Product Change Notice

Description	4ti-0750/TA/12 tooling updates
Creation Date	24th June 2022
Product Change Notice Number	2208
Revision	Revision A
This Product Change Notice supersedes the following documents:	N/A

8. Specification of current & replacement products

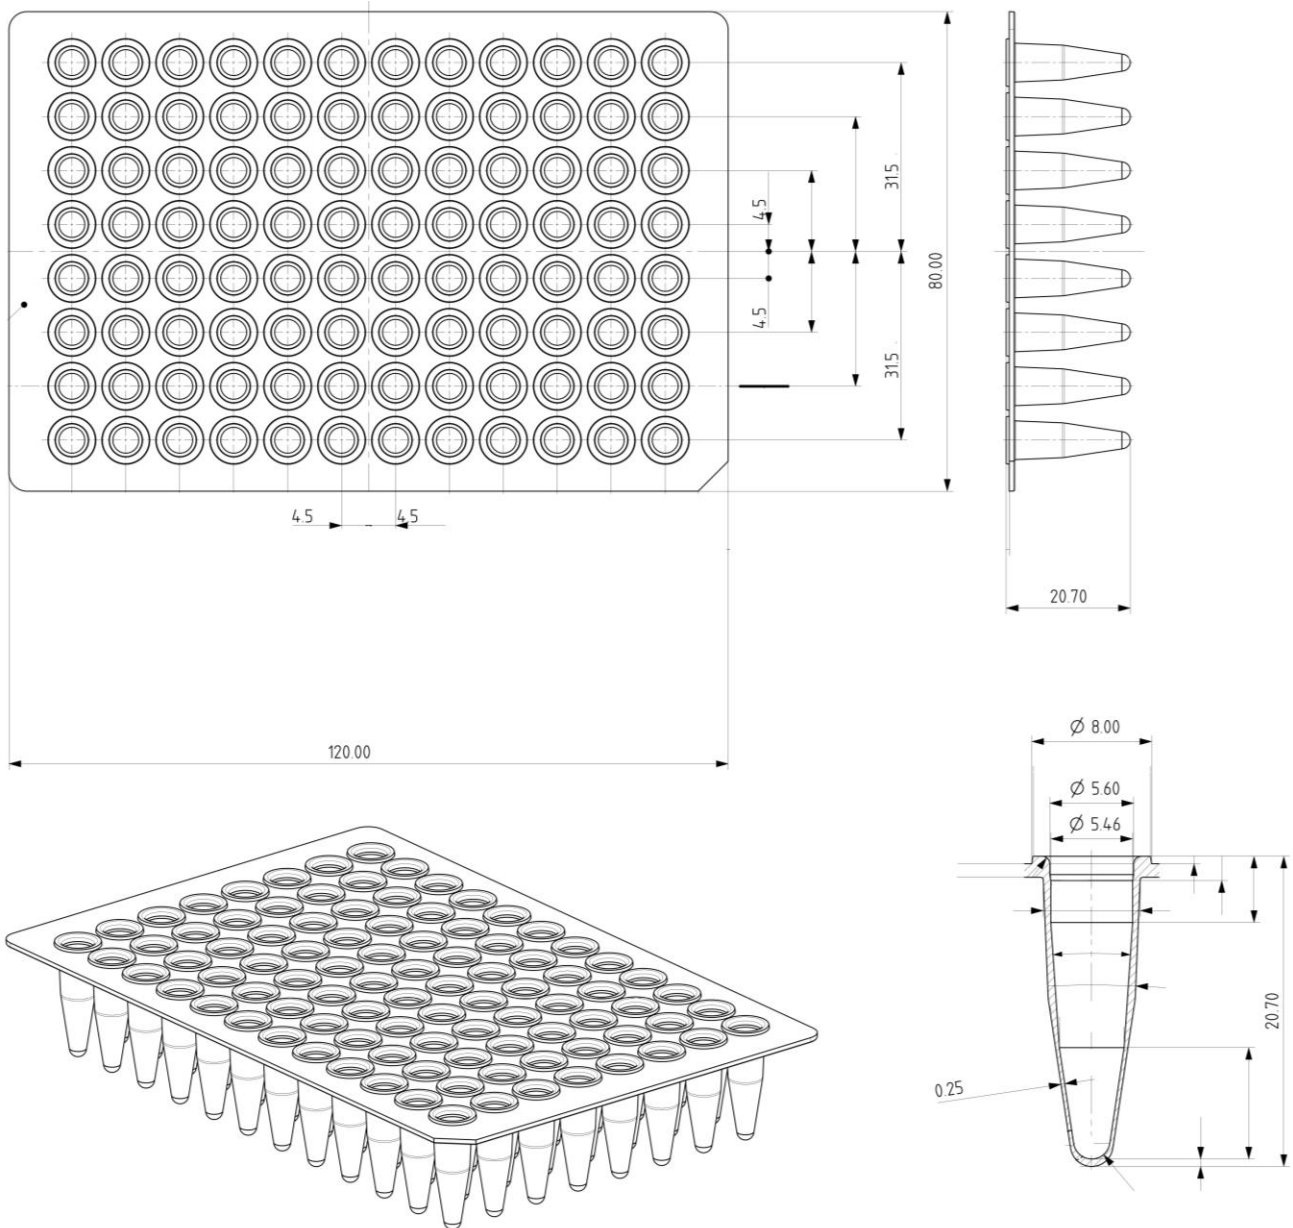
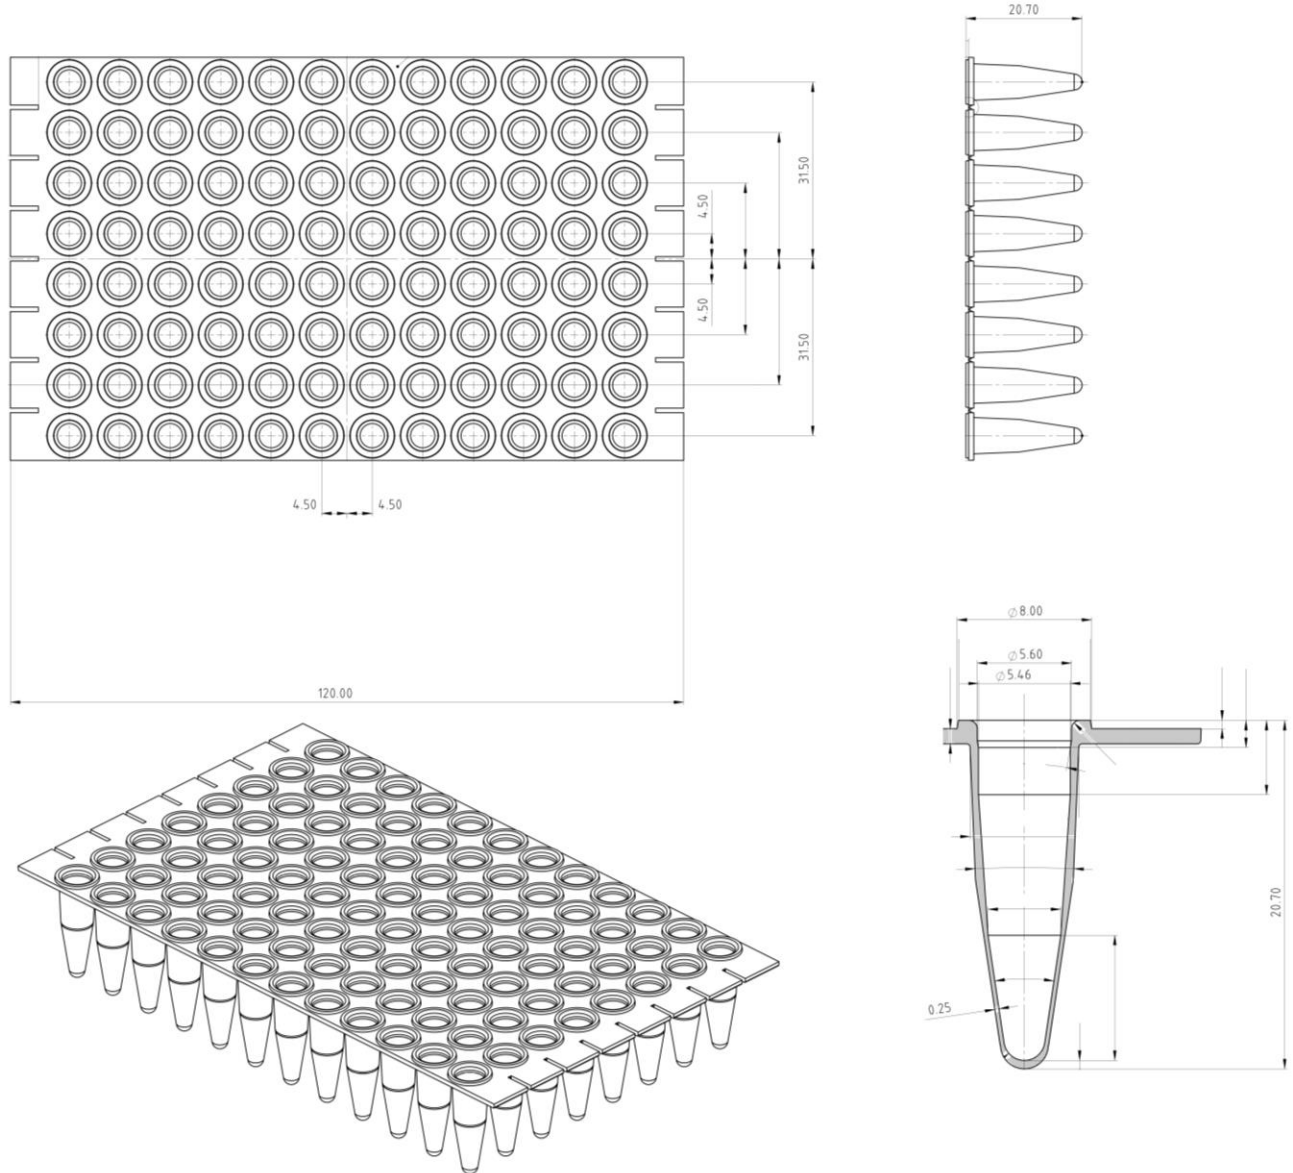
The primary difference is the deck of the plate will be smaller and as such, the alphanumerical grid references will be removed. As this product is used in strip/segment format – we have intentionally removed these references to reduce the amount of unnecessary plastic in the plate, ultimately resulting in less wastage. Offering a more environmentally friendly product that simultaneously eliminates manufacturing difficulties posed by previous tooling.

Additionally, the new design requires for a user to ‘tear’ 12 well strips away from the main body of the plate, rather than ‘break’ or ‘snap’ 12 wells strips off. The original design occasionally led to issues such as uneven breakage, or potential damage to other parts of the frame, deck, or wells of the plates. This new design mitigates against these issues, alongside offering a greater level of useability and reproducibility.

As a result of tooling changes, there will be minor changes to the plates appearance. The deck of the plate will be smaller, and the alphanumeric references will be removed with no expected impact to intended use or compatibility.
